Product Revision Notice: Plastic Case LED driver Label Sticker Revision

2018/01/25

二、Revised Illustration:

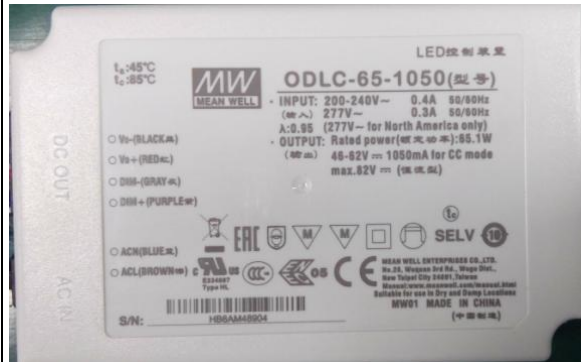
Revised Series	<p>HLN-40H/60H/80H Series LCM/25/40/60 Series IDLV/C-25/45/65 、ODLV/C-45/60 Series PLC-30/45/60/100 、PLN-20/30/45/60/100 Series DAP-04 、SDP-01 Series</p>
Before	<p>Stickers are attached by man power, and the printing ink easily fades away due to weather.</p>

After

Adopted automated laser engraving printing method.
